**ALERT SERVICE BULLETIN**

NO. 412-10-143

**MODEL AFFECTED:** 412, 412EP

**SUBJECT:** HIGH FORWARD CROSSTUBES, P/N 205-050-403-031, 412-050-046-101, MANDATORY INSPECTION

Figure 1

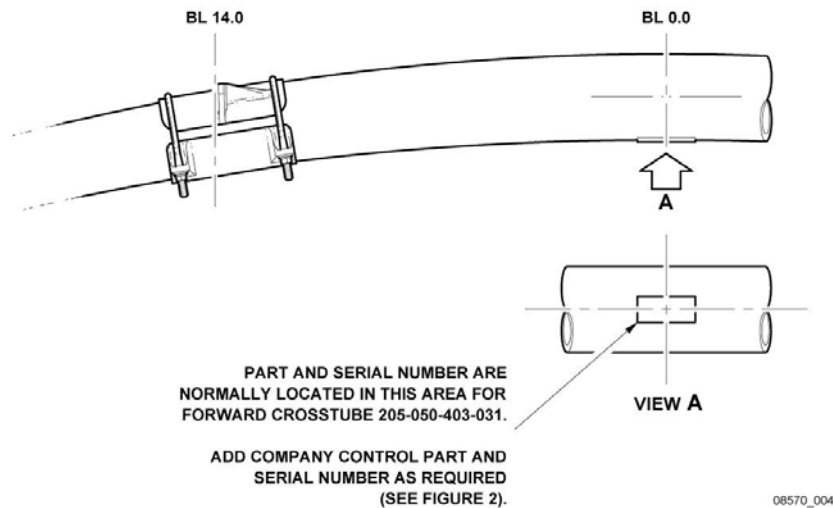
High forward crosstubes assemblies P/N 205-050-403-031 are identified by the use of a decal at BL 0.0 lower side, see Figure 1. If this decal is no longer legible or is missing, determine crosstube part number using helicopters records.

Figure 2

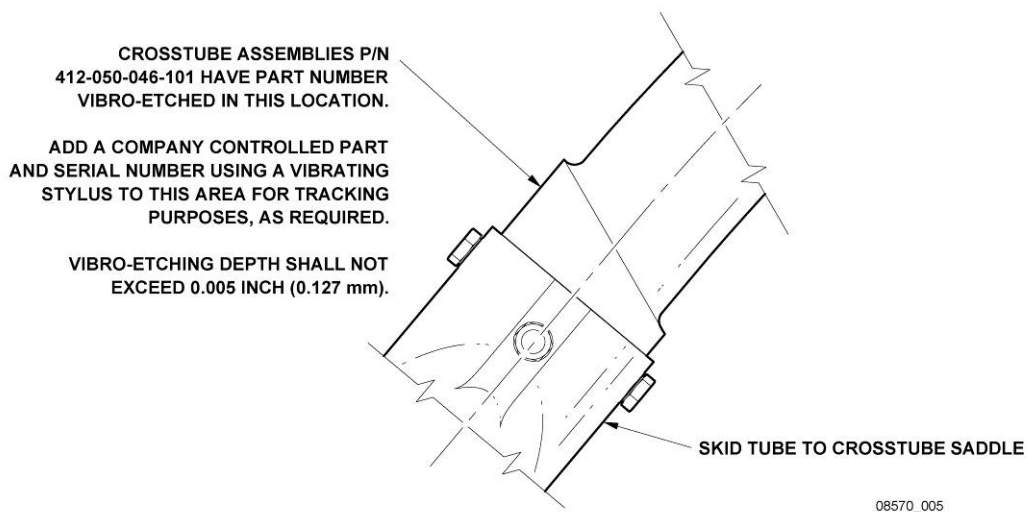
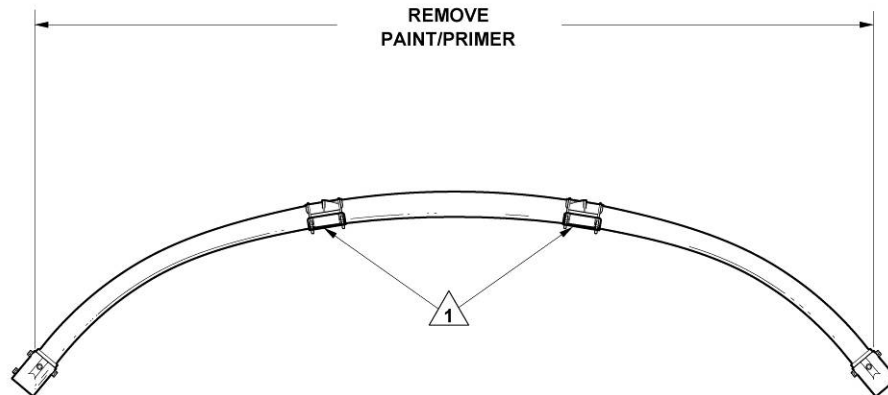
High forward crosstubes assemblies P/N 412-050-046-101 have a part number that is vibro-etched on the crosstube adjacent to the skid tube saddle as indicated in Figure 2.

3. Bell Helicopter Textron crosstubes not clearly displaying a visible part and serial number are required to be identified. The part and serial numbers are to be vibro-etched on the crosstube adjacent to the skid tube saddle as indicated in Figure 2. Vibro-etching depth of this information shall not exceed 0.005inch and shall be accomplished as indicated.

A) Crosstubes using a two piece saddle arrangement (P/Ns, 205-050-132-001, 205-050-133-001) are to indicate P/N 205-050-403-031FM and a company controlled serial number.

B) Crosstubes using the single upper saddle ( P/N 412-050-038-101) that is riveted to the crosstube and a lower composite film abrasion strip (206-050-301-109) shall indicate P/N 412-050-046-101FM and a company controlled serial number.

**Figure 3**

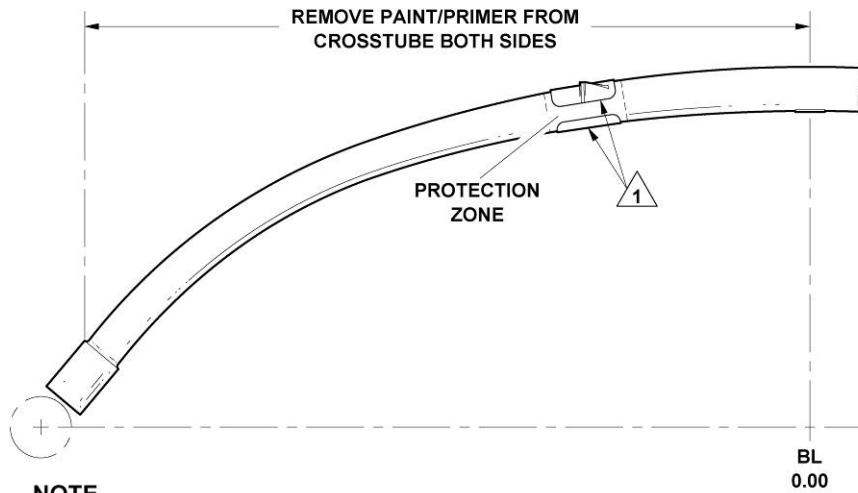
2. Prepare crosstube for the inspection process by removing paint on the crosstube.
  - a. Crosstube P/N 205-050-403-031 will require the exterior paint to be completely removed as indicated in Figure 3. The supports P/N 205-050-132-001 and 205-050-133-001 are removed for this step, as previously indicated.

1 Supports P/N 205-050-132-001 (upper) and 205-050-133-001 (lower) are removed prior to paint removal.
